ADDENDUM 1
RFB #17-0038
RONALD REAGAN BUILDING RENOVATION-FLOORS 4,5,6

**RONALD REAGAN BUILDING RENOVATION – FLOORS
4,5,6
Sedgwick County**

Prepared by:
Schaefer Johnson Cox Frey Architecture, Inc.

Date
10 MAR 2017
**5TH FLOOR
NEW
CONSTRUCTION/DEMO
PLAN-POWER**

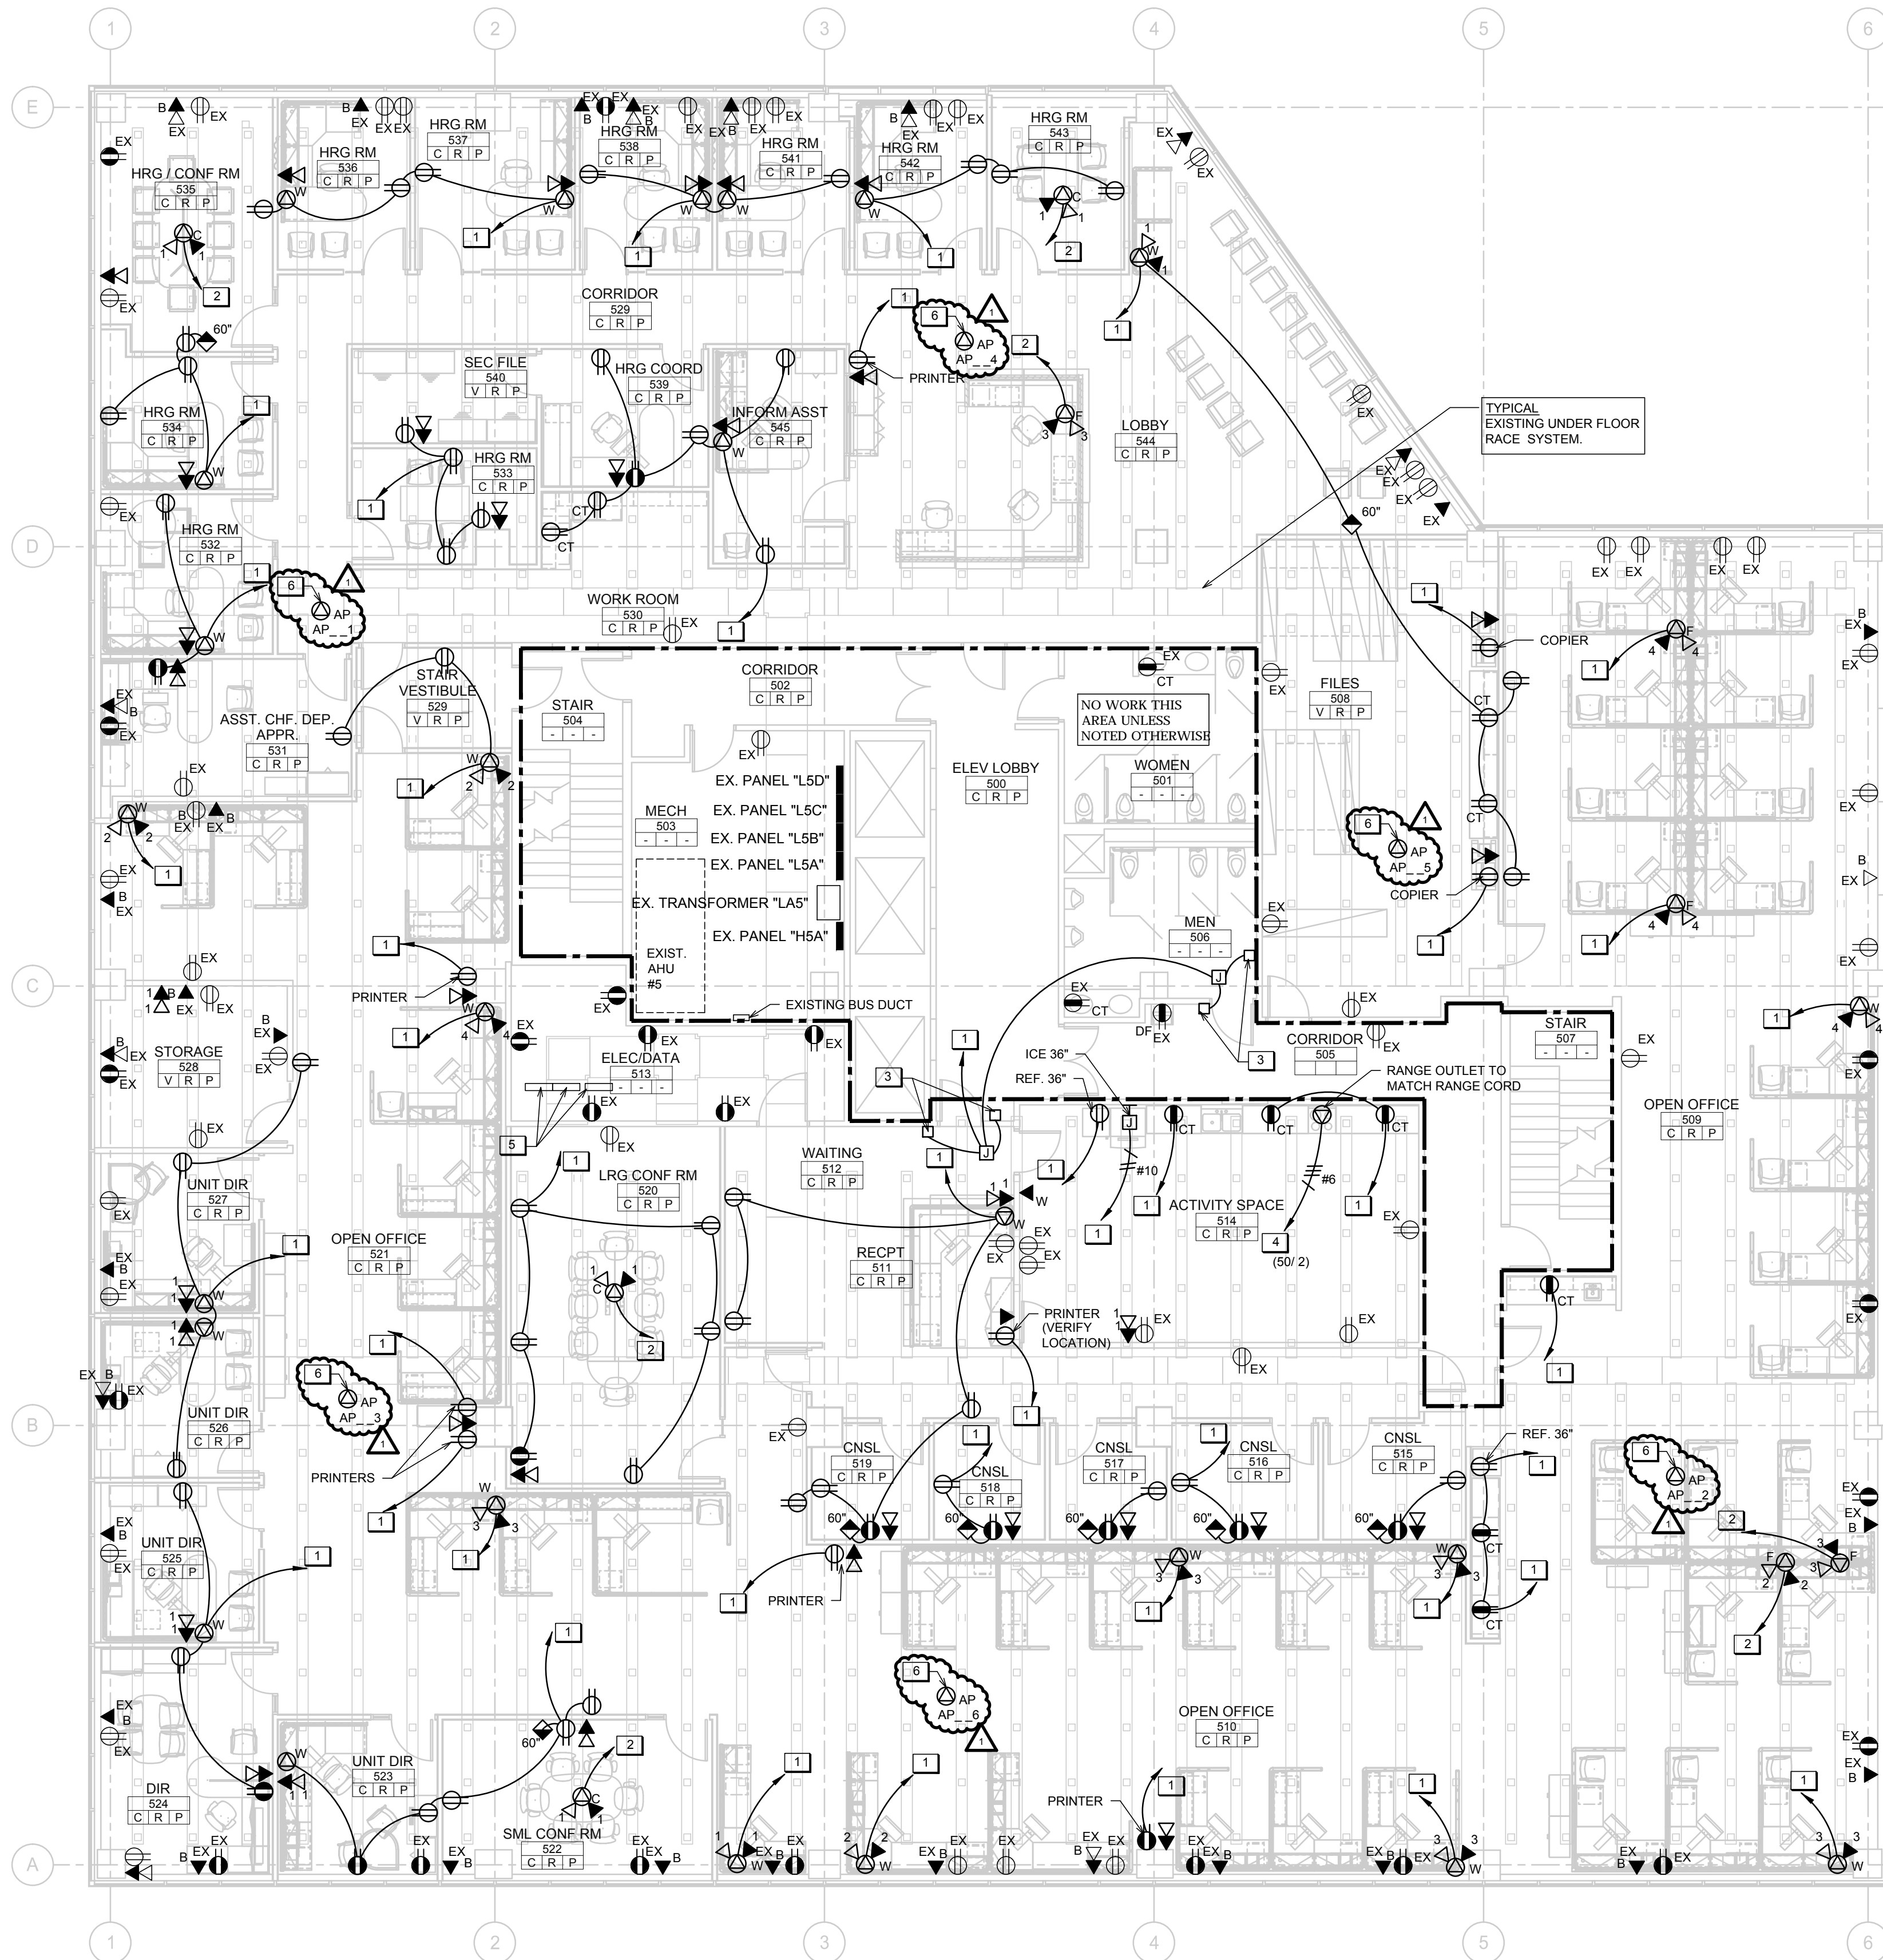
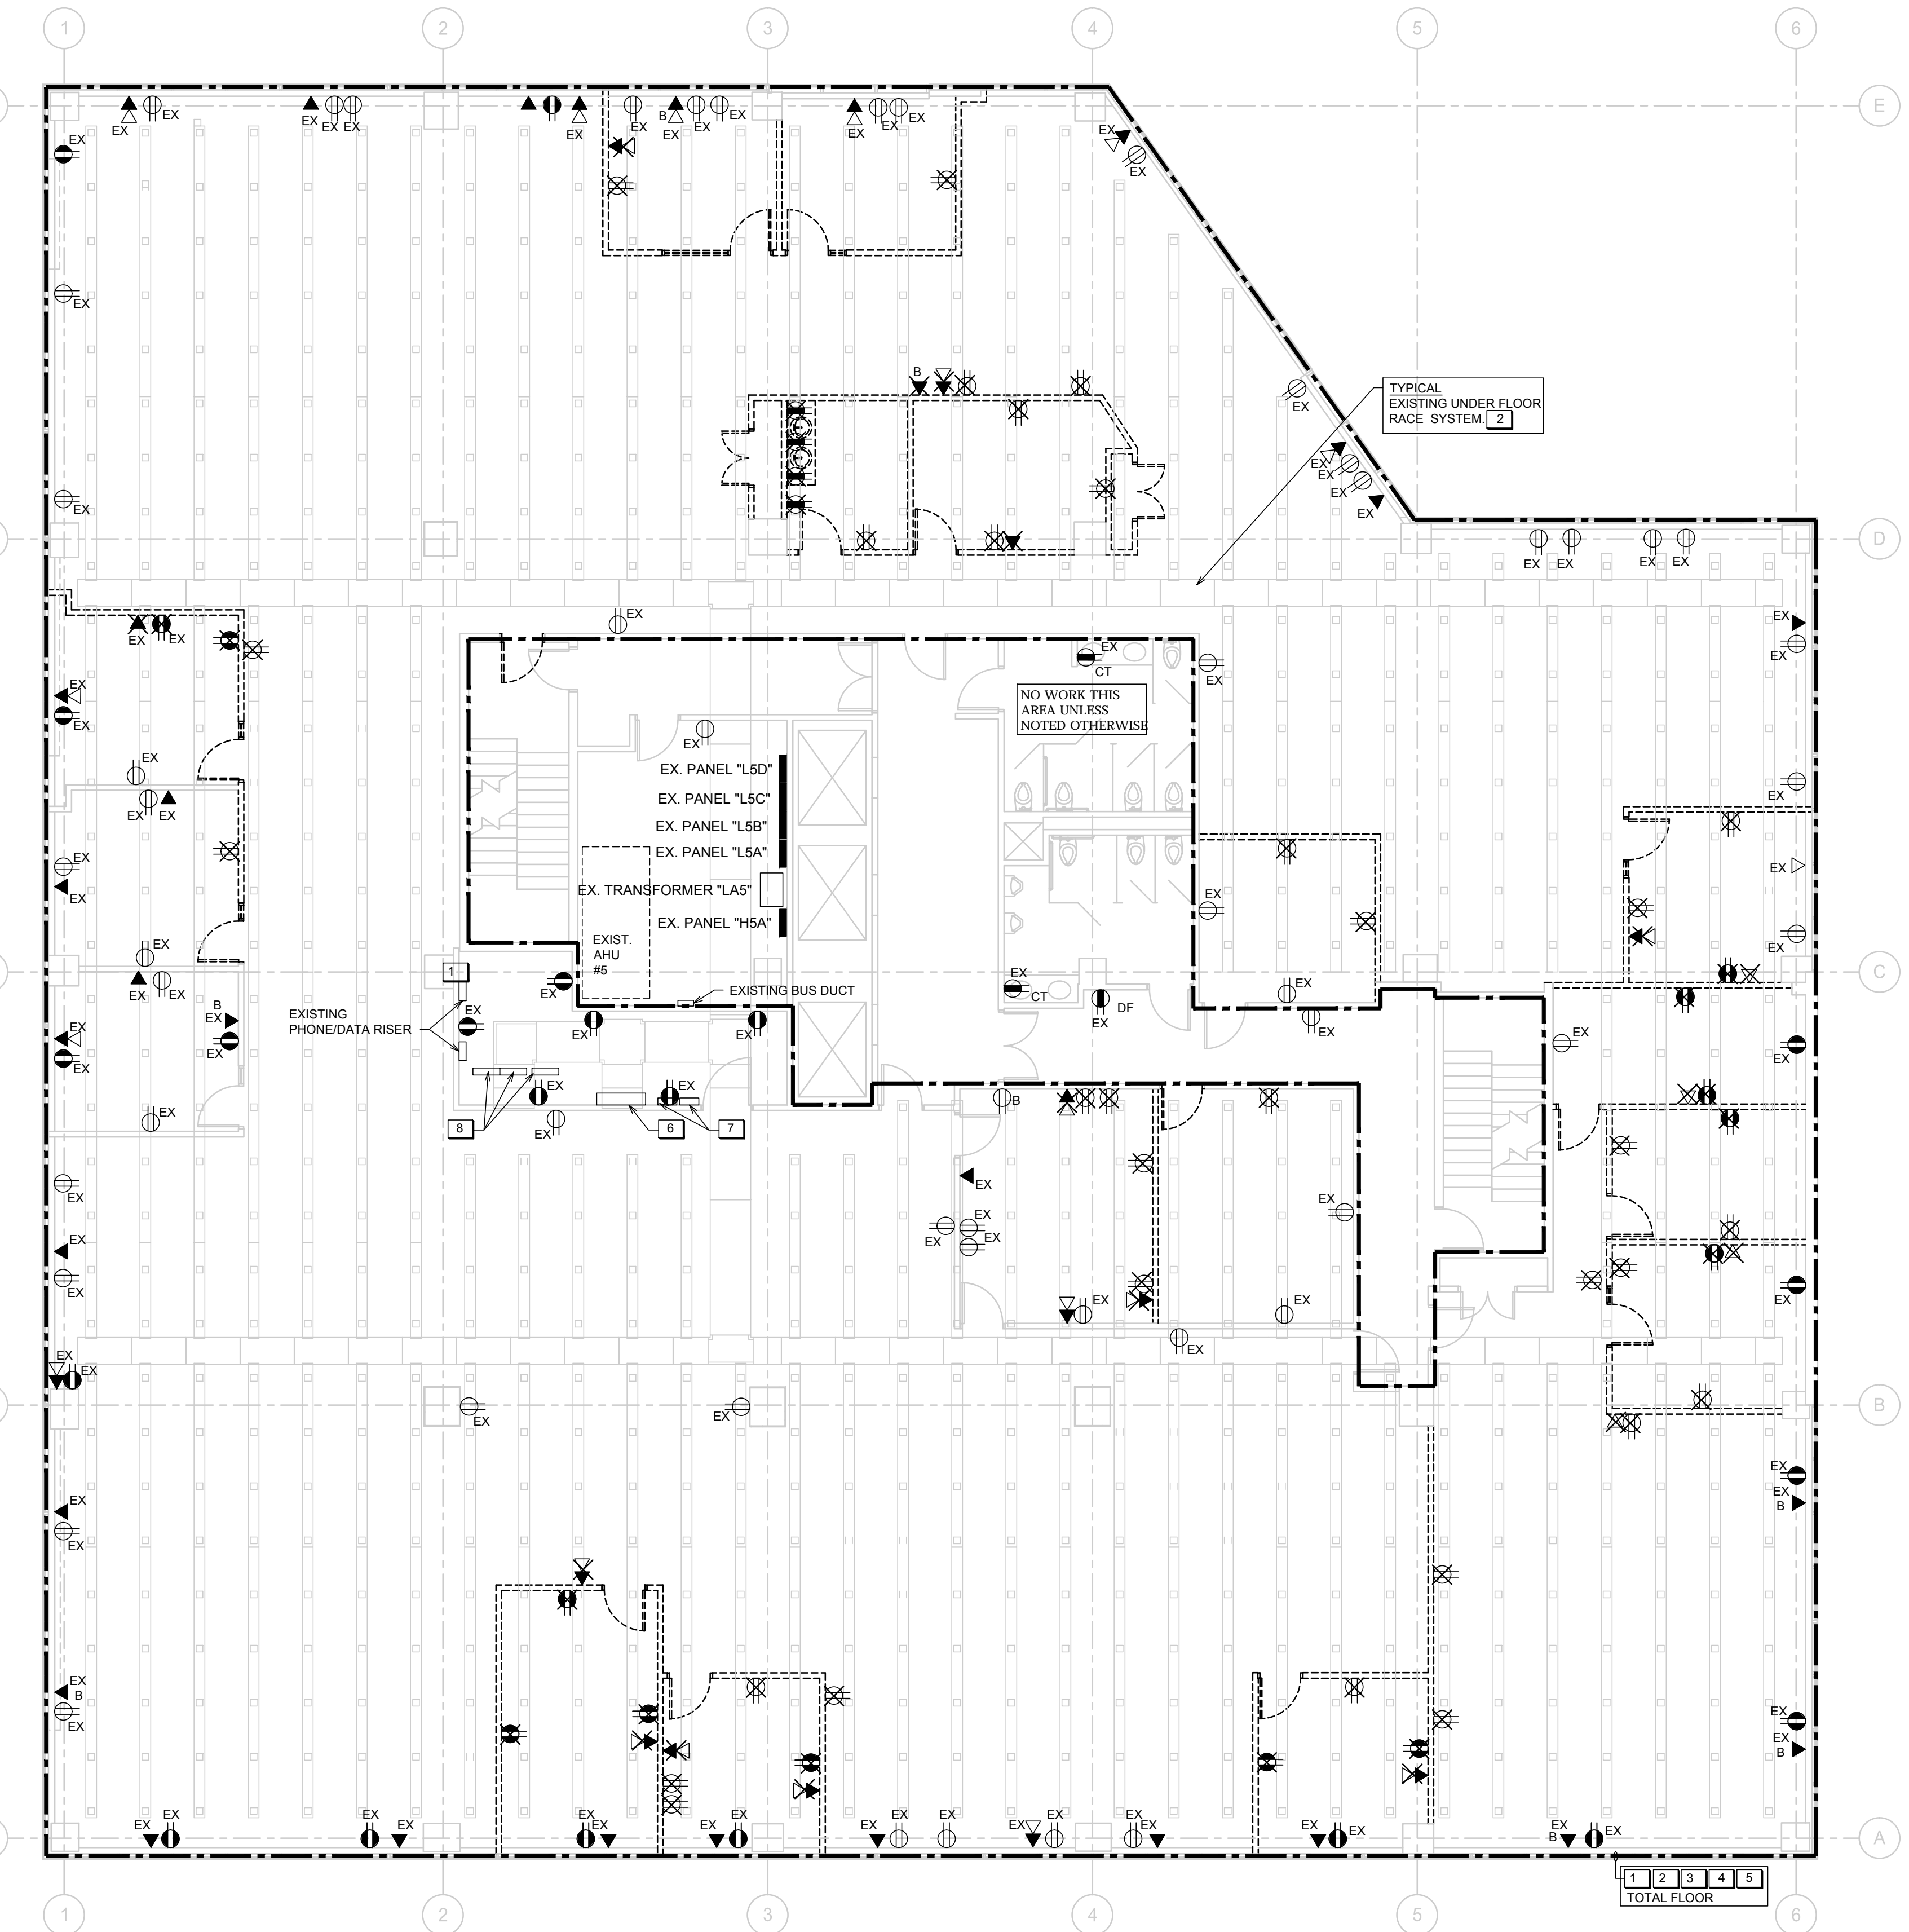
5 **ITEM AD1-E01** PLAN SHEETS E23.1, E24.1, E25.1:
ADDITION: Add cabling for Wireless Access Points per symbol type "AP" and plan notes
5 and 6 per attached sheets E23.1R, E24.1R and E25.1R.
